Re: Revision To Administrative Order No. WFX-697  
Grayburg-Jackson Waterflood Project  
Eddy County, NM

Please accept our request to amend Administrative Order No. WFX-697 to include the following:

**DEVON ENERGY CORPORATION  
APPLICATION FOR AUTHORITY TO INJECT  
GRAYBURG-JACKSON WATERFLOOD**

## DEVON ENERGY CORPORATION WELLBORE SCHEMATIC

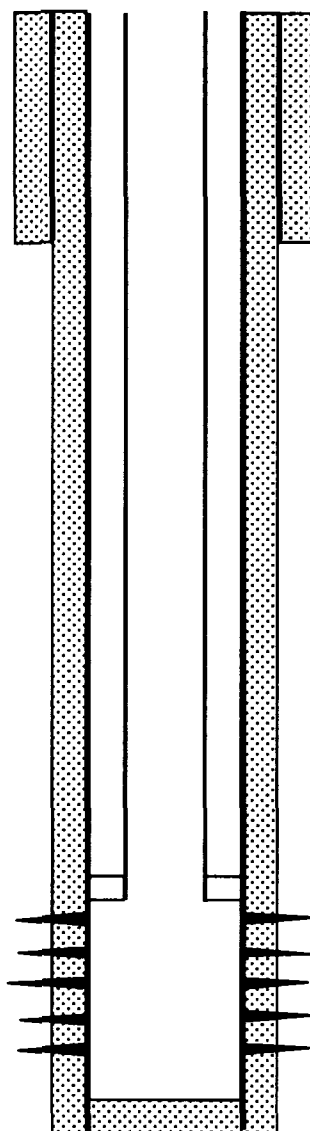
REPLACE

This well is a proposed redrill of the C.A. Russell #4. It is necessary due to the poor mechanical integrity of the production casing which rendered the original well unsuitable for injection. The C.A. Russell #4 has since been plugged and abandoned per OCD regulation.

8 5/8" CASING @ 450', CEMENT TO SURFACE.

INJECTION INTERVAL: 2740'- 3537'

BAKER AD-1 PACKER @ 2700'

PERFORATIONS: 2740'- 3537' (OA)

5 1/2" CASING @ 4200', CEMENT TO SURFACE.  
TD @ 4200'
